265 Levere-H Rd.

SEPTIC SYSTEM INSTALLATION CHECKLIST (310 CMR 15.030)

SYSTEM INSTALLATION OBSERVATION REPORT

SHEET NO. 1 OF 1.			
SCALE	AS SHOWN	REV. DATE	DESCRIPTION
DRN. BY	S.K.	2 9/29/03 S.K.	AS-BUILT
CHECKED	D.M.	1 6/9/03 S.K.	REVISED TEST PIT DATA
APPROVED:		DATE	JOB NO.
DOUGLAS J. MACLEAY REGISTERED PROFESSIONAL ENGINEER		MAY 14, 2002	2002-072-9
TITLE: SUBSURFACE SEWAGE DISPOSAL PLAN IN AMHERST, MASS.			
FOR: AMHERST BUILDING COMPANY, LLC LEVERETT ROAD

SITE PLAN

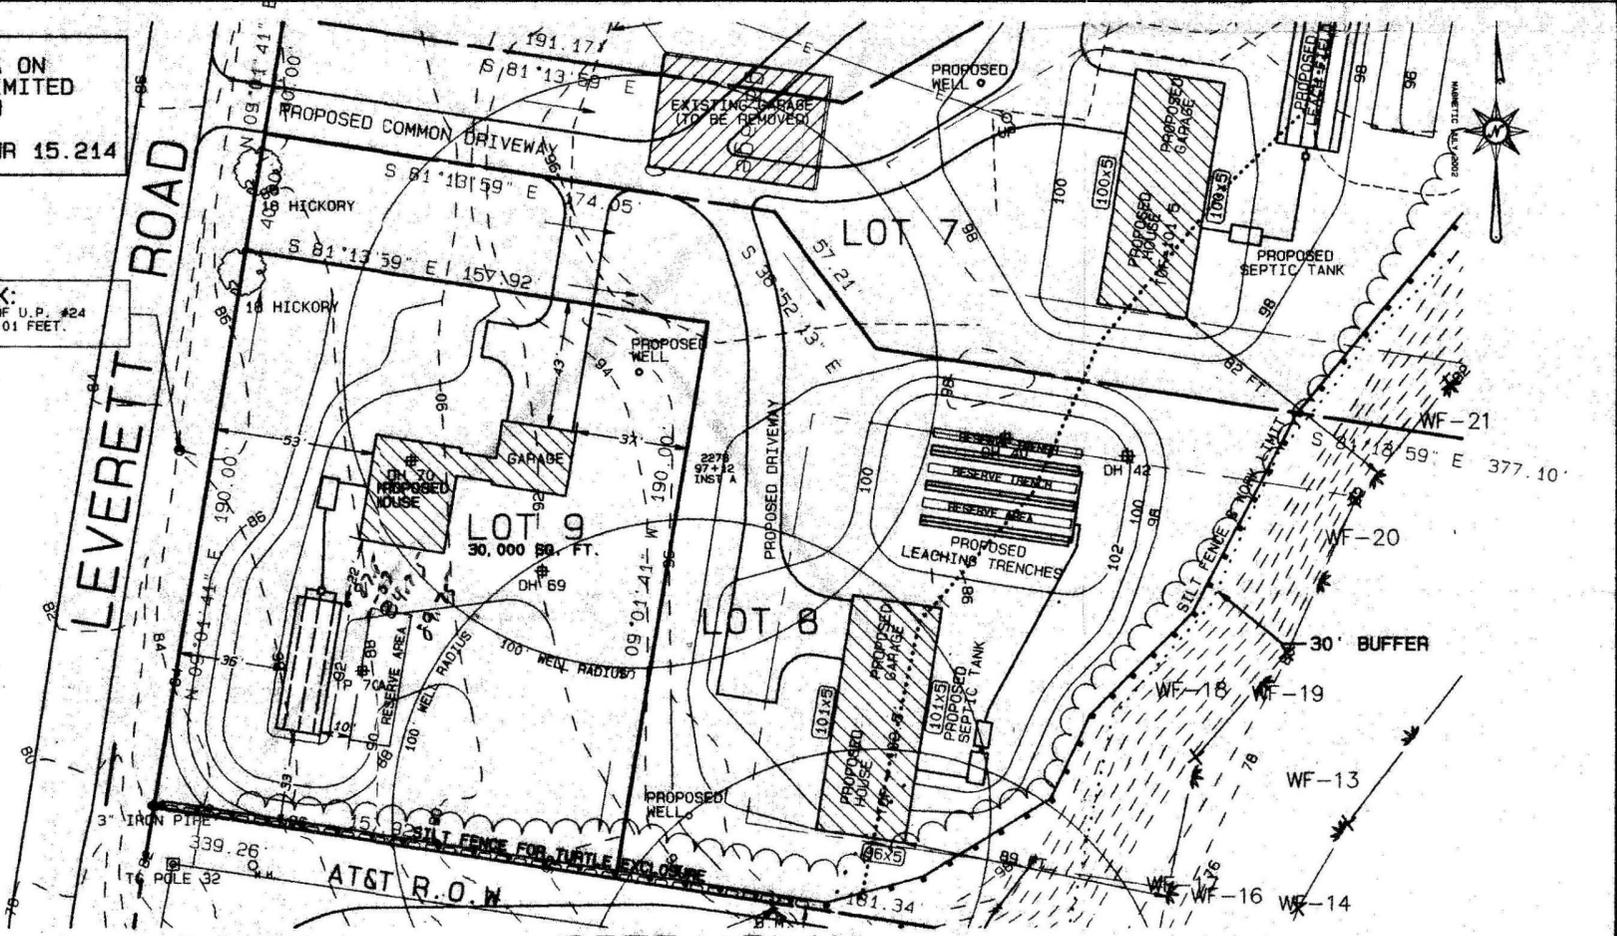
THE DIFFERENCE BETWEEN
THE INLET AND OUTLET TIES
IN THE SEPTIC TANK AT
265 LEVERETT ROAD WAS $\frac{1}{2}$ "
IT SHOULD BE 3" ACCORDING
TO THE PLAN.

Notes: 1/2" DIFFERENCE BETWEEN INLET AND OUTLET TEES MUST BE 3" PER PLAN.

~~I TOLD~~ THE INSTALLER
SAID HE WILL CORRECT IT
I TOLD HIM NOT TO COVER
THE TANK UNTIL AFTER
HE TALKS TO YOU.

DOUG MACLEAY SAID HE WILL SEND
US AN AS BUILT WITH THE TIES AND
GRADES ON IT. ~~TOM~~
